MCPB
Item No. 6
Date: 10-31-13

Rosemary Hills Elementary School, Mandatory Referral, MR2014008

Date of Staff report: 10/18/13

Proposed Site Plan

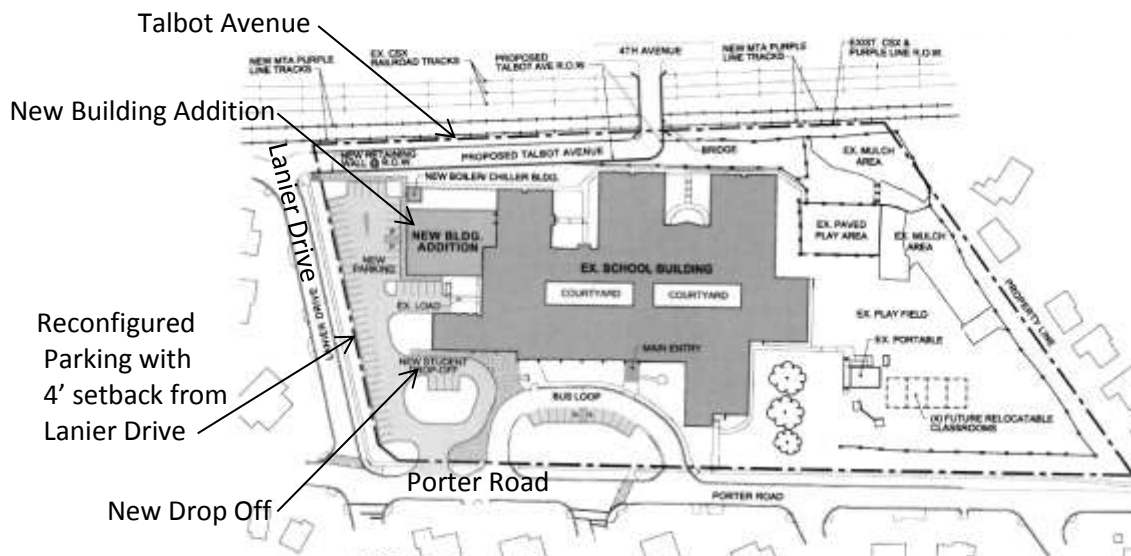
The proposed addition and site improvements fit the neighborhood well. They are consistent with the development standards of the R-60 zone, which are the standards for the private development of one-family detached homes in this neighborhood. However, the proposal does not meet the zoning ordinance standards for a privately owned parking lot in a residential zone. Those standards require a 25 foot setback where the provided setback is 4 feet.

This is acceptable in this case due to the characteristics of this particular retrofit and the fact that this is a public facility which is not legally required to adhere to standards in the zone and those for parking.

Proposed Landscape Plan

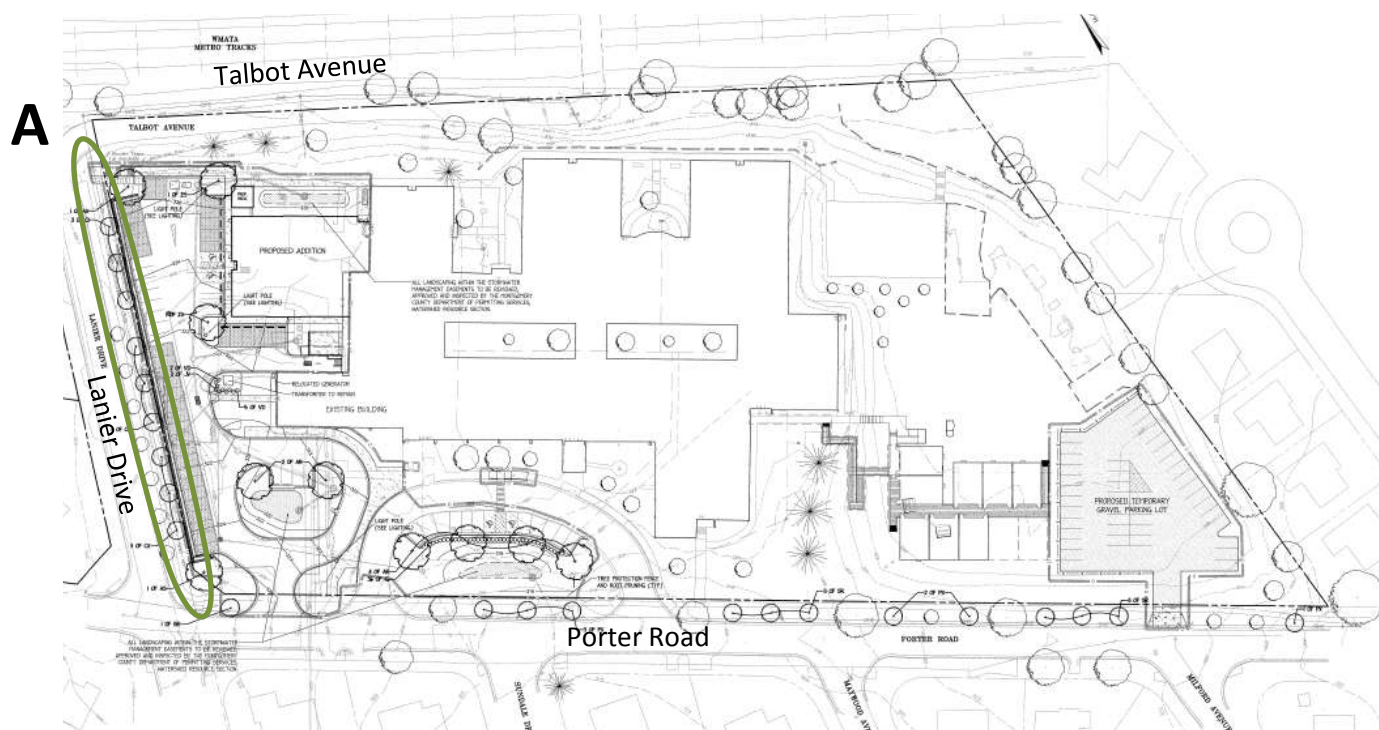
1. The Applicant should improve sidewalks along the entire site frontage to provide a consistent width of five-feet to replace the existing four-foot wide sidewalks.
2. Provide additional low plantings in combination with the proposed ornamental trees on Lanier Drive to further green and enhance the parking lot setback.

The parking lot is between six and ten feet below the existing grade of Lanier Drive. This reduces the visual impact of the parking lot. However, the parking lot is only 4 feet from the property line which is less than that required for a privately developed parking lot in the zone. Due to the site constraints, the elevation change and the proposed planting of new trees at the existing grade of Lanier Drive, this is acceptable to achieve compatibility with the residential properties opposite Lanier Drive. Additional low plantings under the new ornamental trees should be provided to further enhance the setback. See "A" on the proposed landscape plan that follows.
